RE: **Approval of Plans (REV 1)**
TDOT Gibson County Maintenance Building
1248 B Manufacturers Row
Trenton, TN 38382

TFM # 21267
Project # 2023-11-09-02
County: Gibson

Revision #1 Drawing Changes

TECH. FIRST
FLR./MEZZ.
BUILD-OUT
T1.1

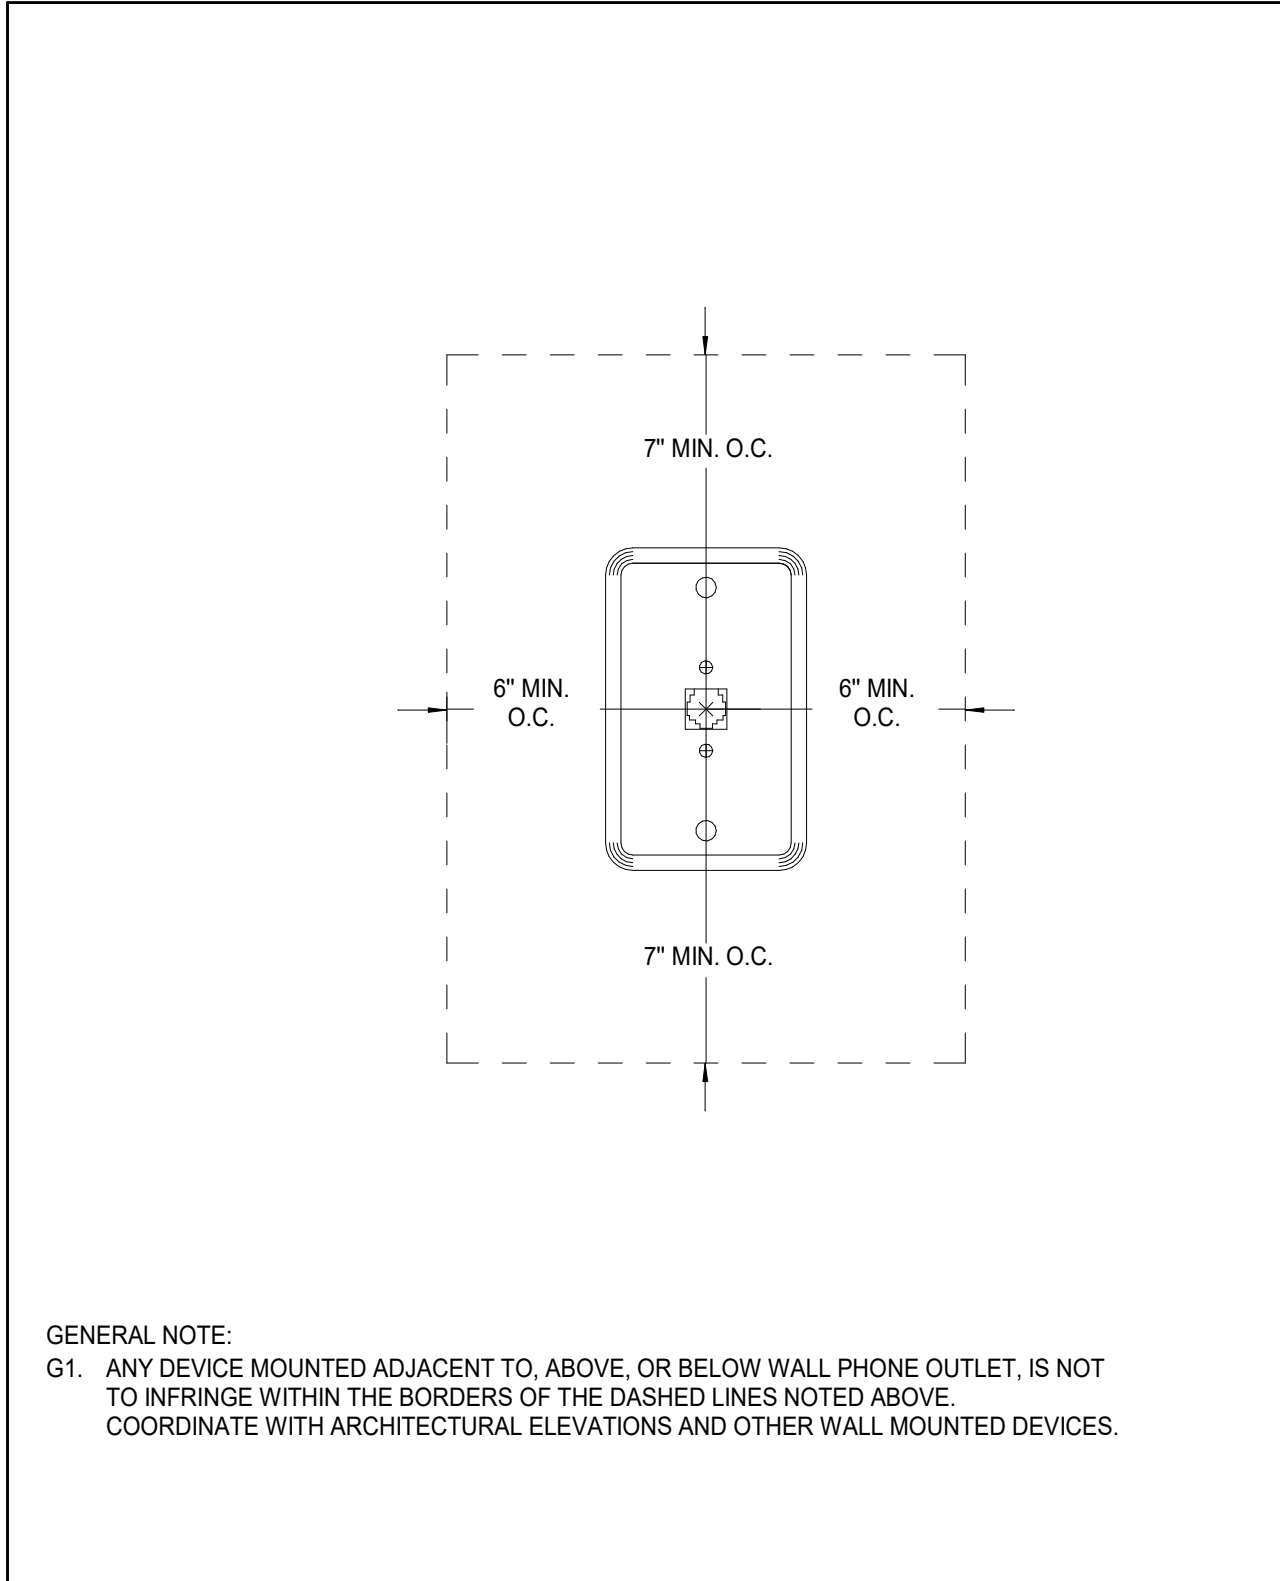
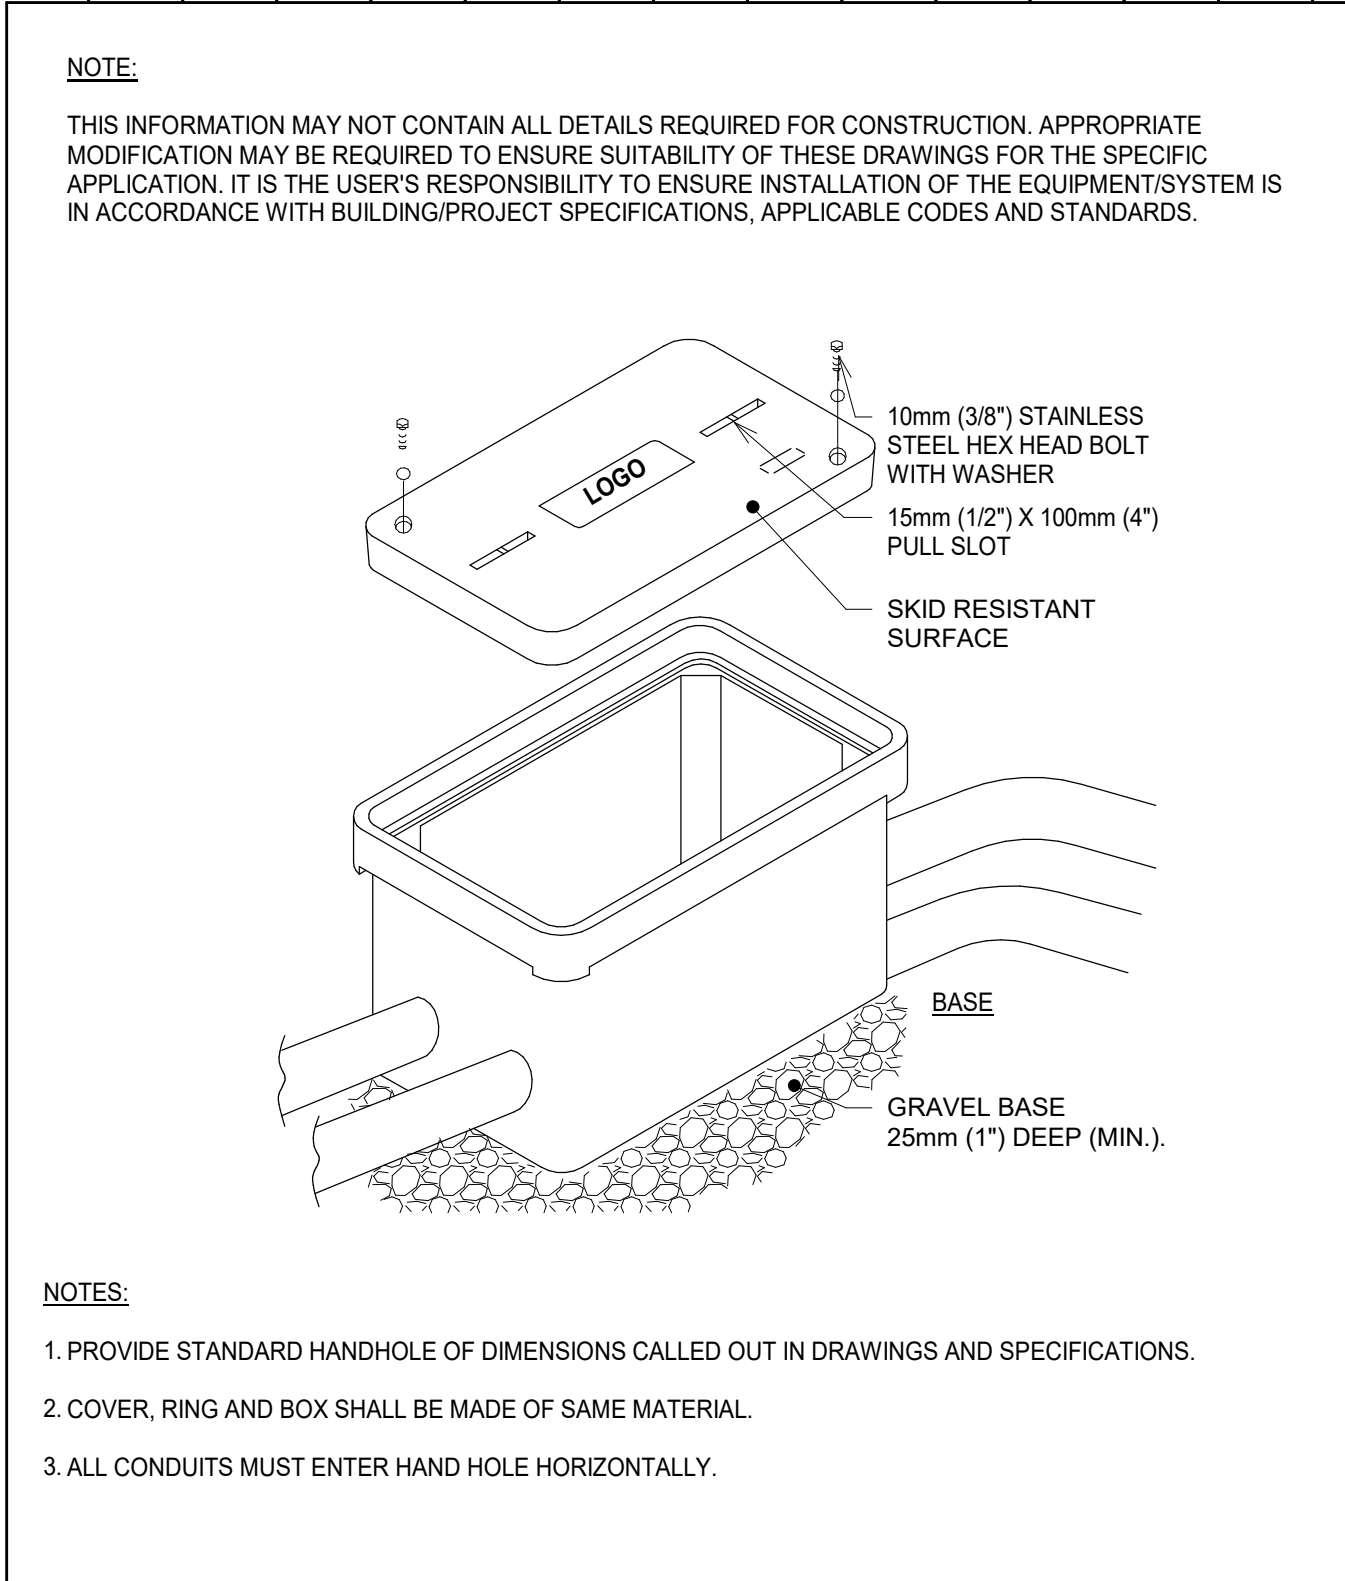
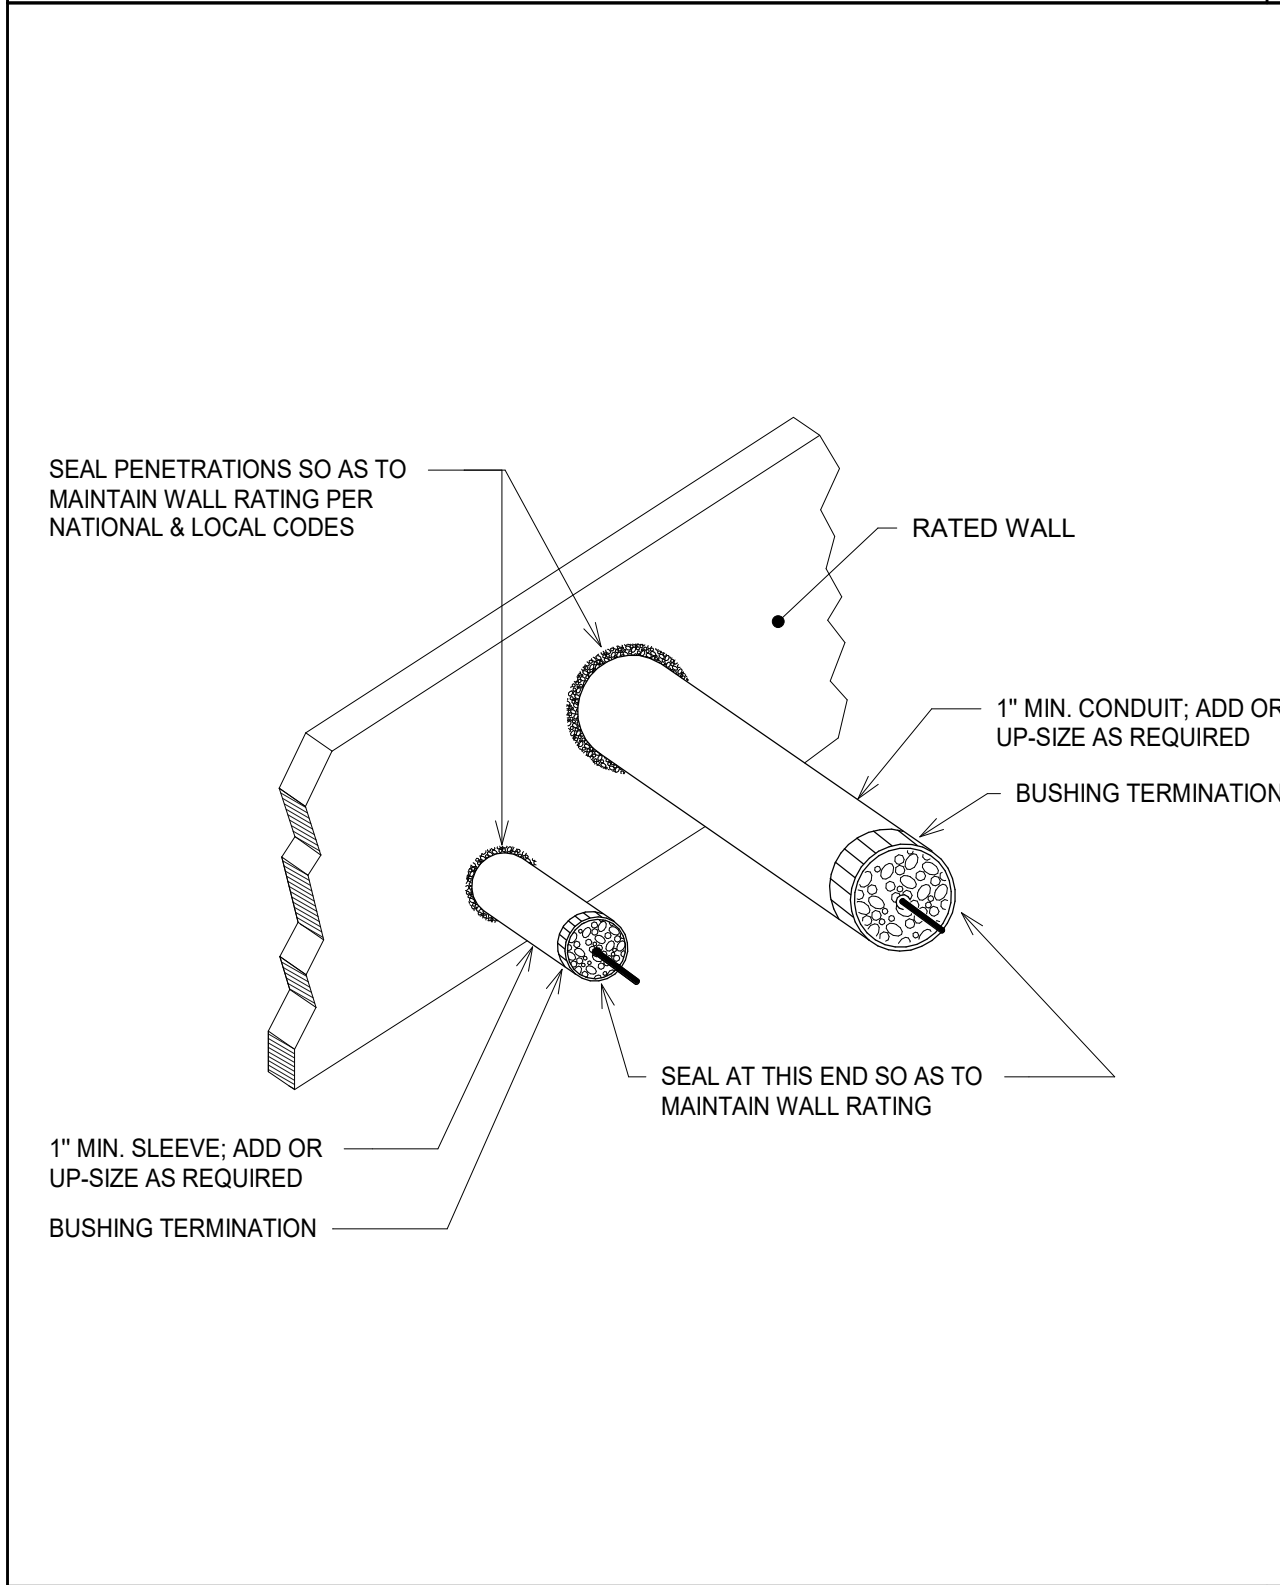
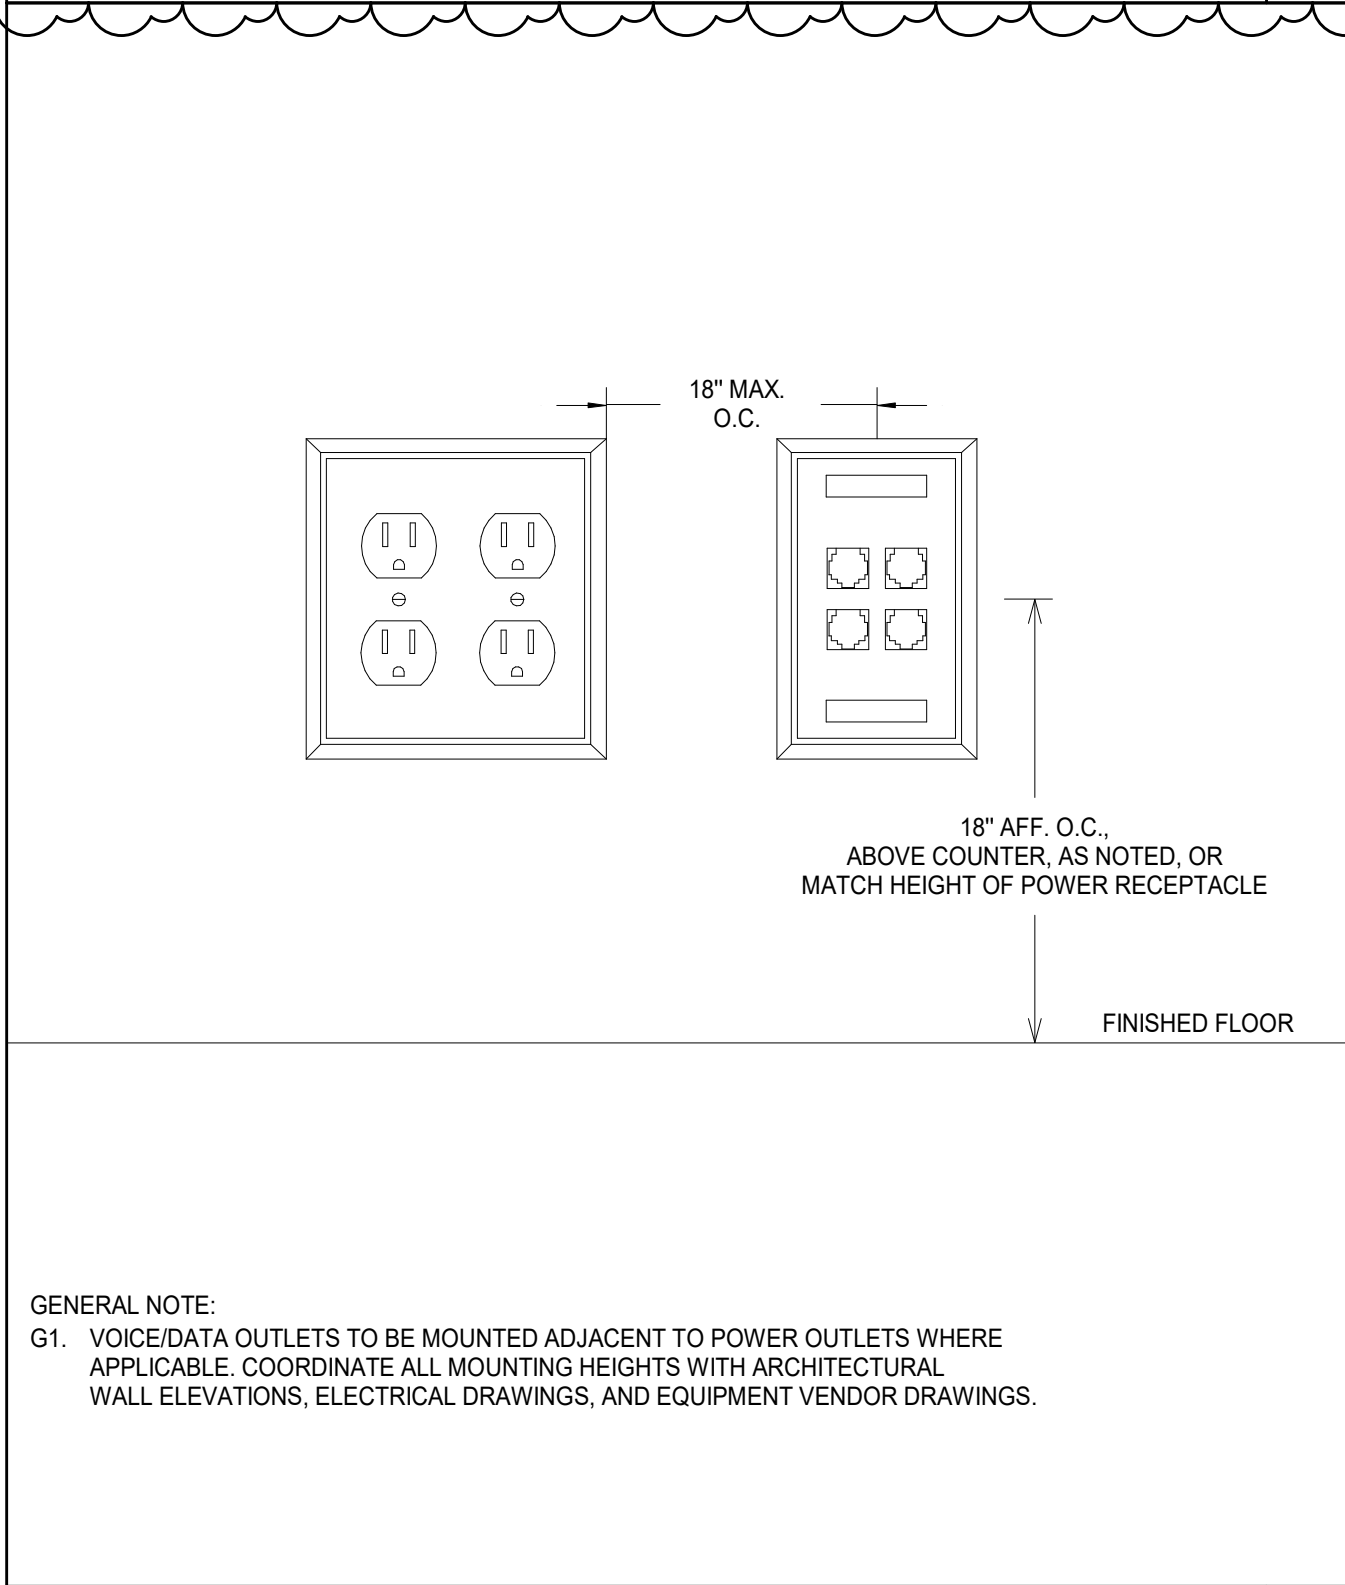
Sheet T1.1: Revised location of door to IT room, removed all plan callouts and notes related to STS equipment, added and moved data receptacles on the mezzanine
